UNITED STATES PATENT AND TRADEMARK OFFICE

Office Action Summary	Application No. 10/517,342	Applicant(s) LANG ET AL.
	Examiner VICTORIA HICKS	Art Unit 3772

DETAILED ACTION

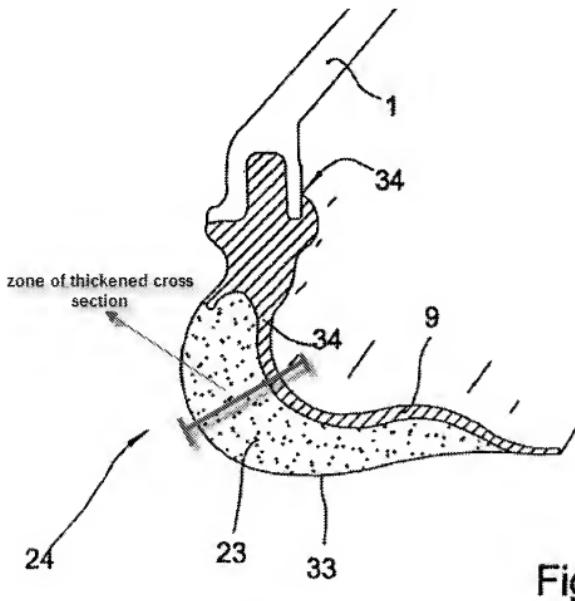
with a gel or foam material (23). The structure 9 taught by Lang et al. constitutes a "stem" in that it is a long, slender part. In response to Applicant's argument that Lang et al. does not teach the forehead pad having a zone of thickened cross section, it is clear from Figure 7 of Lang et al. that the forehead pad (24) has a zone of thickened cross-section and in the zone is provided with a gel or foam material (23). Please see the annotated copy of Figure 7 of Lang et al. that is provided below.

In regards to claim 31, Lang et al. teaches in [0025] that the forehead pad base body (1) is made from an elastomer material. In Figures 4 and 7 Lang et al. teaches that the base body (1) has a coupling portion (34) for fixing the forehead pad (24) to a forehead support device (1) and a stem portion (9) for radially yieldingly mounting a forehead contact portion provided (24) for bearing against a forehead surface, wherein the forehead pad (24) has a zone of thickened cross-section and in the zone is provided with a gel or foam material (23).
